Courtyard enclosure study · closing the conditioned house around the open courtyard · Taif / Palm House V7.1

Design review Y-01 (critical) · 30 Oct 2026 · the windows follow `docs/DESIGN_LANGUAGE.md` (black steel, divided lites)

DECIDED: option A (owner, 30 Oct 2026, applied in V7.0): the projection 1.55 m, B3 / R11 / C21–C23 at x 5.80, W1 / W2 / W3 as in § 2. The "now" column below is the V6.3 state (edge x 5.60), kept as the record of the comparison.

Plans of the gallery strip, first floor · now / A / B · the sky opening and the void · about 1:115 on A4

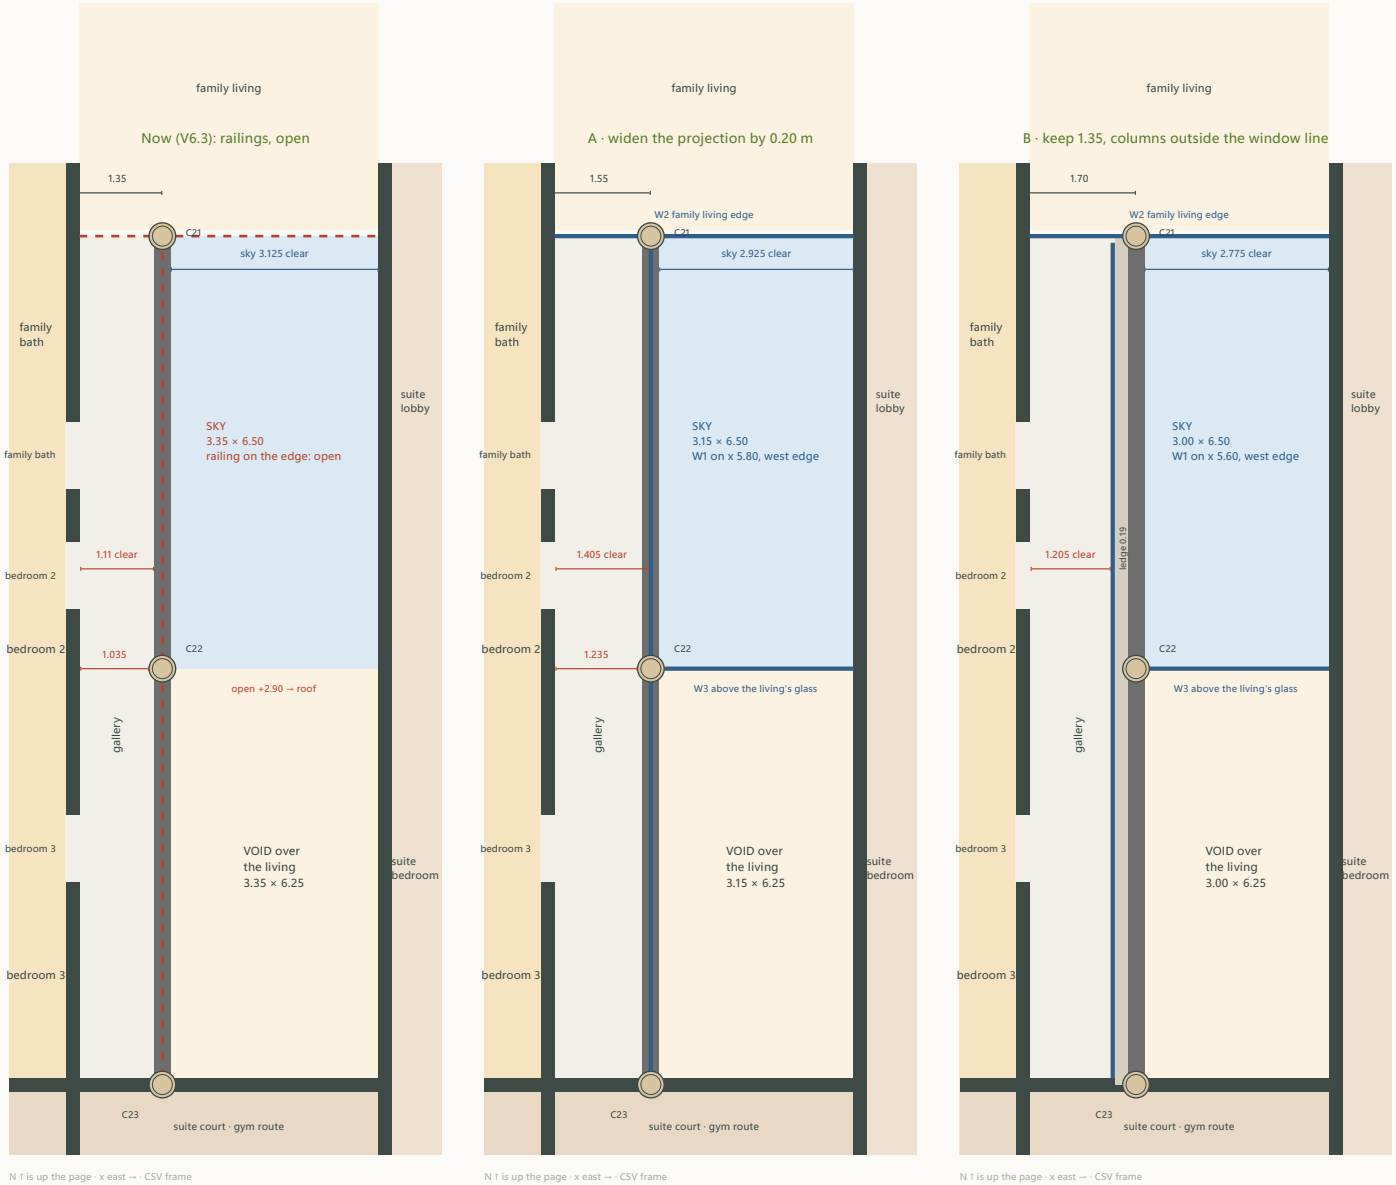
Today the gallery is 1.11 m clear between the rooms' finished wall face (x 4.365) and the upstand of B3, and 1.035 m at the three stone column sleeves (Ø0.4). A window on the line changes little by itself; the columns are the problem. Two ways to reach 1.20 m:

Dark: walls and the edge beam B3 (0.25 wide, upturned 0.30 above the slab). Blue lines: the new steel windows W1 / W2 / W3; red dashed: the open railings of today. Columns: the stone sleeve Ø0.4 round the Ø0.3 core. In B the beam and the columns leave the window line and a 0.19 m ledge lies between the glass and the beam (capped in stone, falling to the courtyard). The gallery doors are the V6.3 1.00 m openings.

4 · Recommendation: A **A** keeps everything on one line: the beam, the columns, the window and the railing base are the same element, the gallery is 1.405 m clear and 1.235 m at the columns, the sky loses 6 % of its area and stays 3.15 m wide on axes. **B** reaches 1.20 m with no margin (1.205 m), narrows the sky more (3 m: the beam and the roof edge must follow the columns), and adds a 0.35 m ledge outside the glass that must be waterproofed, capped and kept clean; its one real gain, free-standing columns in front of a glass wall, is a stronger colonnade image. If the owner wants that image, B is buildable; otherwise A. In both, the two-storey columns, the upturned B3 and R11 stay as decided (X8); only their x changes. **Study checks passed** (7)

Sections through the courtyard (y ≈ 10, looking north) · A and B · about 1:105 on A4

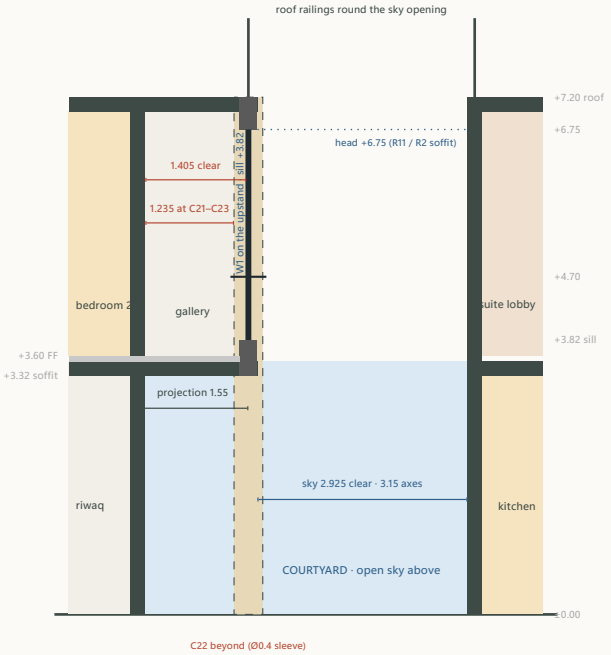
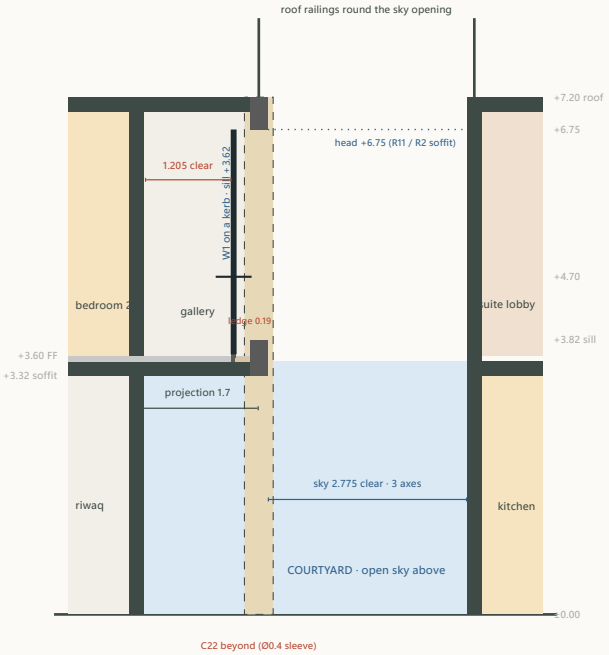
A · widen the projection by 0.20 m · section at y ≈ 10 looking north

B · keep 1.35, columns outside the window line · section at y ≈ 10 looking north

Dark: walls, slabs, the roof; grey: the upturned edge beam B3 (0.25 × 0.50 total, 0.30 above the slab) and the roof edge beam R11 above it; the dashed column is C22 (y 13.0) beyond the cut. W1 (heavy black line) sits on the upstand (A) or on a 0.10 m kerb inboard of it with a stone-capped ledge outside (B); its guarding transom at +4.70, its head at +6.75 under R11.

W1 · the gallery line seen from the courtyard and the void (looking west) · option A · 1:70 on A4

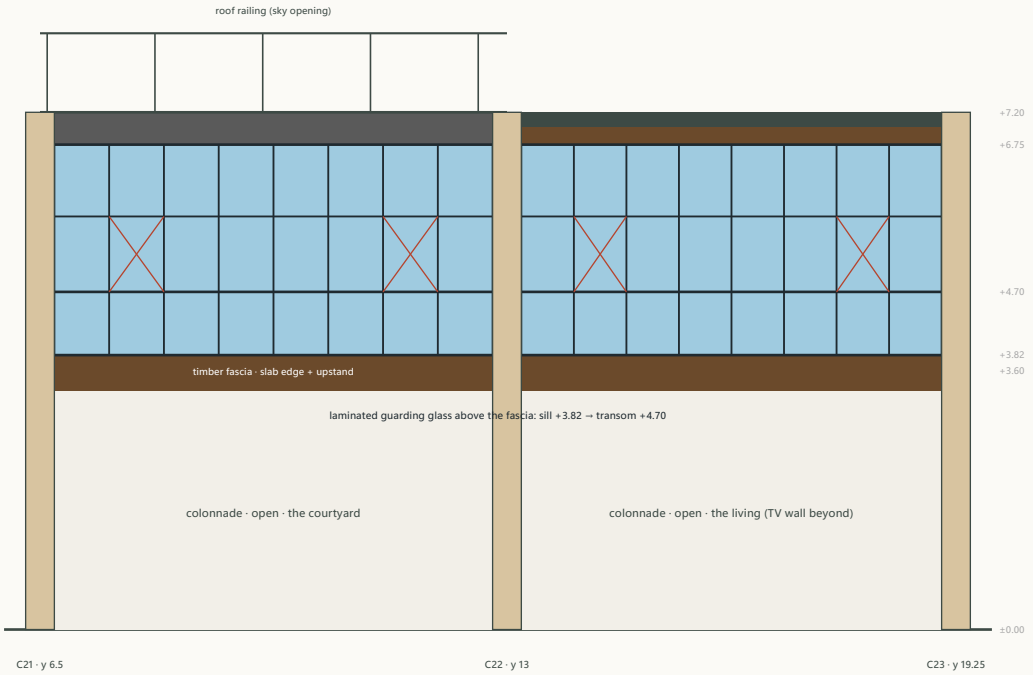
V7.1 (owner, 31 Oct 2026): semicircular heads and the courtyard arcade. Every enclosure window gets a semicircular (Roman) arched head in black steel with divided lites, the arched head fixed, the rectangular part below with the operable lites; the sill and the guarding transom (+4.70) as in § 2. **W1:** six arched windows 1.60 m wide on the gallery edge, three per column bay, sill +3.82, springing +5.80, crown +6.60, 0.15 m of wall below the R11 / R2 soffit (+6.75): in the courtyard bay they stand over the three bays of the new arcade (y 6.783–8.383, 8.950–10.550, 11.117–12.717), in the void bay on three equal bays (13.242–14.842, 15.325–16.925, 17.408–19.008); the four casements sit in the lower parts. **W2:** two arched windows 1.30 m wide east of C21 (x 6.00–7.30 and 7.55–8.85), floor to the crown +6.60, springing +5.95; the strip x 4.25–5.80 of that edge is the family living's opening to the gallery's north end, no window. **W3:** one arched window 2.80 m wide (the whole space between C22's stone sleeve and the east wall; the brief said ≈ 3.0) over the living's courtyard glass, +3.32 to the crown +6.60, springing +5.20, the two motorised tilt lites in its lower part; 0.15 m of wall to the R2 soffit. **The arcade:** in the courtyard bay only, two slender honey-stone columns Ø0.25 on x 5.80 at y 8.667 and 10.833 (three equal bays of 2.167 m on axes) with three semicircular arch plates under the projection's soffit (+3.27): spans 1.84 / 1.92 / 1.84 m between the sleeves, springing +2.35 / +2.31 / +2.35, crown +3.27; decorative unless the engineer uses the columns (`studies/structure.typ` X18); the living bay keeps no arches. The columns stand 0.78 m clear of the sunken seating's west edge, 1.36 m clear of the riwaq door's swing line, 1.33 m from the riwaq glass face; the malqaf outlet is on the east wall. The courtyard reads as a two-tier arcade: three arches below, three arched windows above.

black steel, divided lites ≈ 0.75 wide · transoms at +4.70 (guarding) and +5.75 · red X = inward side-hung casements, two per bay (night mode, cleaning) · about 35.01 m² of glass · A · widen the projection by 0.20 m
